## **Access Compliance Report Public Rights-of-Way** (Curb Ramps)

Intersection ID: 15806 Main Street: EAST BV **Cross Street: MARYLAND AV** Location: SW ADA ID: AD5A7F3053EA Ramp Type: BlendTrans2 Initial Pass/Fail: Fail **Overall Compliance: No Severity Score:** 1.25

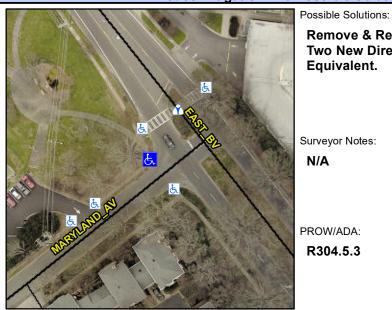
Street 1 Name Stop Condition-Street 1 Street 2 Name Stop Condition-Street 2 **Remove & Replace Curb Ramp With Two New Directional Ramps or** Equivalent.

R304.5.3

Comp	liance Description	Data	Comp	liance Description	Data
N/A	Ramp Length (in)	86.0	Yes	BlendTrans Slope (%)	3.3
Yes	Ramp Width (in)	73.0	No	BlendTrans XSlope (%)	4.0
N/A	Flare Type LT	N/A	N/A	Flare Type RT	N/A
N/A	Flare Slope LT (%)	N/A	N/A	Flare Slope RT (%)	N/A
N/A	Flare Traversable LT?	N/A	N/A	Flare Traversable RT?	N/A
N/A	Landing Length (in)	N/A	N/A	DWS Provided?	N/A
N/A	Landing Width (in)	N/A	N/A	DWS Contrast?	N/A
N/A	Landing Slope (%)	N/A	N/A	DWS Length (in)	N/A
N/A	Landing X Slope (%)	N/A	N/A	DWS Full Width?	N/A
N/A	Landing Curb? (Y/N)	N/A	N/A	DWS Offset (in)	N/A
N/A	Shared Landing?	N/A			
N/A	Gutter Ponding?	N/A	N/A	Gutter Slope (%)	N/A
N/A	Gutter Lip Ht (in)	0.5	N/A	Gutter X Slope (%)	N/A
N/A	Painted X Walk1?	No	N/A	Painted X Walk2?	N/A
	X Walk 1 Direction	To SE		X Walk 2 Direction	N/A
	X Walk 1 Width (in)	N/A		X Walk 2 Width (in)	N/A
	X Walk 1 Slope (%)	3.0		X Walk 2 Slope (%)	N/A
	X Walk 1 X Slope (%)	1.6		X Walk 2 X Slope (%)	N/A
